**NOTICE OF DECISION TO CONSENT TO AMEND A REFERRED PROPOSAL  
DURING ASSESSMENT**

Katanning Gold Project  
Assessment No. 2564

### **Attachment 1: Amended proposal content document and figures showing changes**

Figure 1: Figure showing changes to Development Envelope

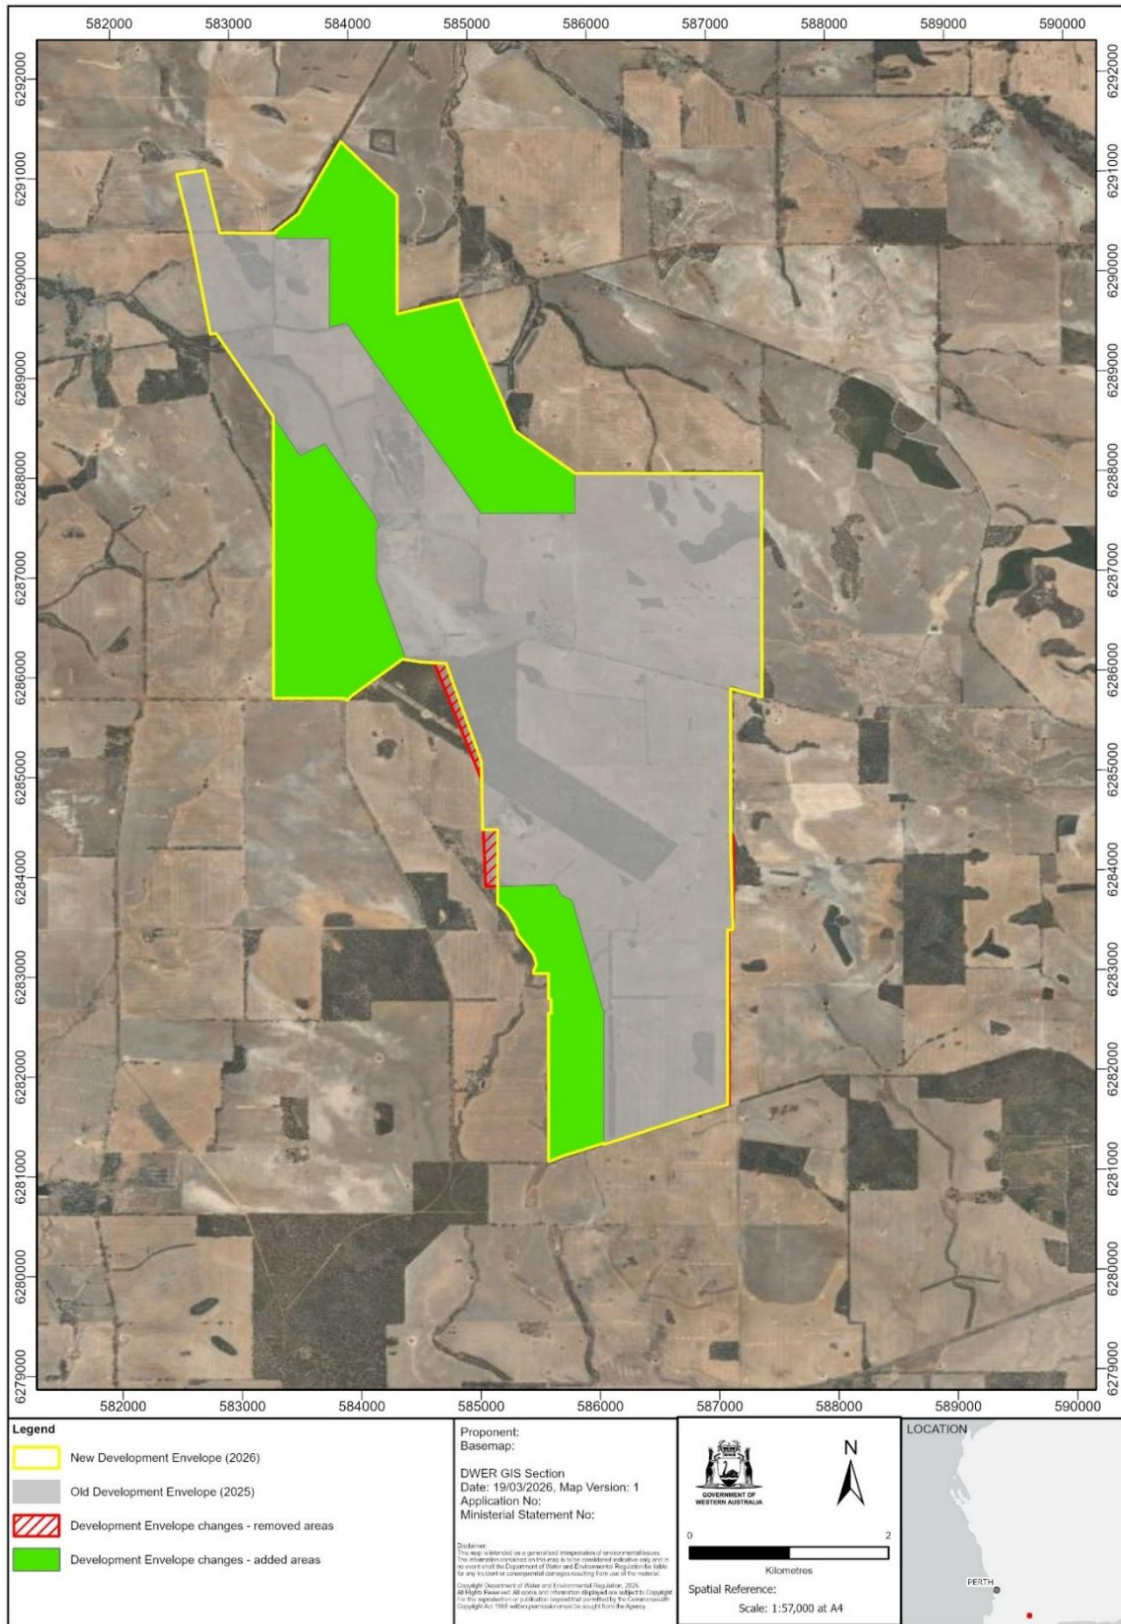
- Increase development envelope from 1,619.02 hectares (ha) to 2,233.82 ha and disturbance footprint from 961.90 ha to 1,141.38 ha.
